John Wood

SAFETY RECALL

Subject: John Wood Oil-Fired Residential Water Heaters, Model Nos. JW517 (50 gallon) & JW717 (70 gallon) (in serial number ranges described below)

Insertion depth in this example is 8.7”.

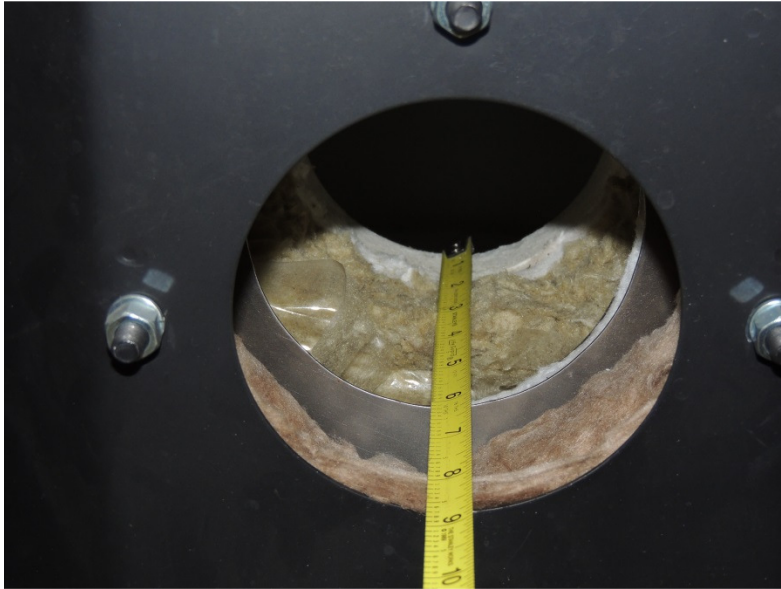
The Issue: The "insertion depth" (the distance from the outer jacket to the interior combustion chamber) on the affected water heaters may in some instances be longer than the 7-8 inch tolerance. In addition, a subset of the affected JW517 units may have inverted radiation shields. Any unit with either an inverted radiation shield or an insertion depth shorter than seven inches or longer than eight inches should be inspected to determine if it should be retrofitted or replaced.

- Provide you with a free replacement water heater for each unit with an inverted radiation shield: model JW517, serial range 1349A021678 to 1429A013935.
- For all other units subject to this recall, we will dispatch a service agent to make an on-site inspection of your water heater. If it needs to be replaced, we will provide you with a replacement water heater free of charge.
